VILLAGE OF LOMBARD REQUEST FOR BOARD OF TRUSTEES ACTION

SUBJECT: SPA 11-02ph: 85 Yorktown Shopping Center (Chase Bank)

VILLAGE OF LOMBARD INTER-DEVELOPMENTAL REVIEW GROUP REPORT

Proposed Chase Bank Branch Traffic Evaluation

Site Circulation Evaluation

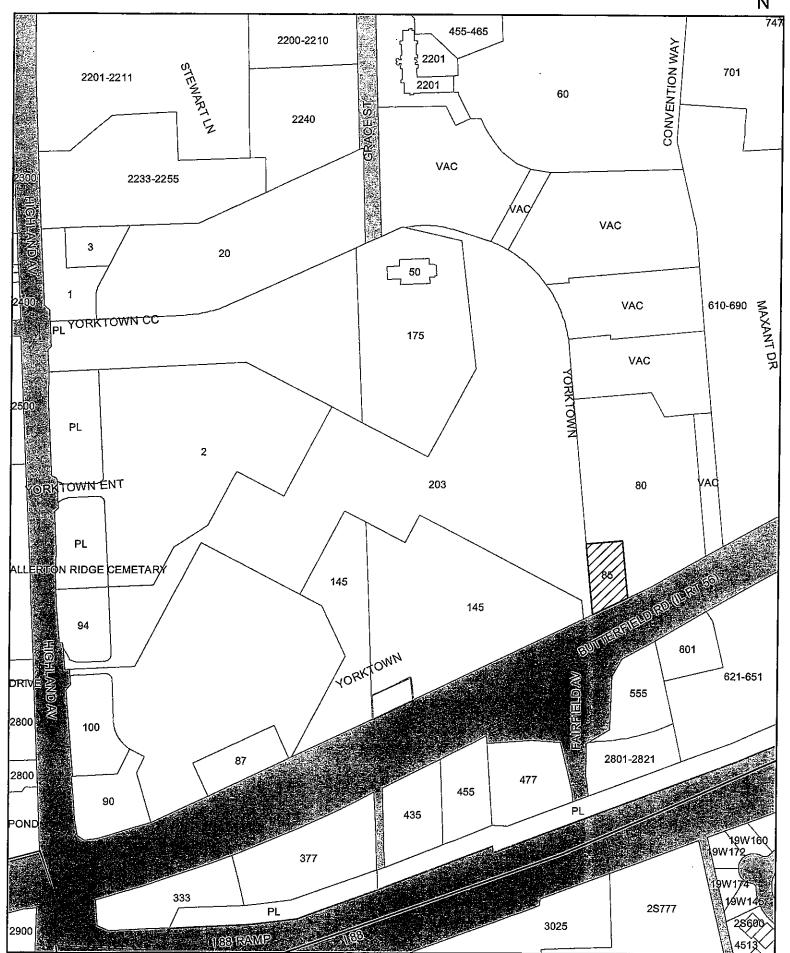
- Circulation within the site is fairly well defined.
- Based on the recommended changes in site access, additional internal signage should be provided directing customers to the various driveways serving the site.
- Drive-through stacking for four vehicles at each window is more than adequate. Studies by KLOA, Inc. at a number of banking facilities has indicated much lower stacking needs.
- The number of parking spaces provided is more than adequate.
- Sign number 6 on the "Sign Location Plan" should be moved further north to provide a better site line to incoming drivers.
- Additional signs directing customers to the drive-through facility may be desired at the other access drives to the site.
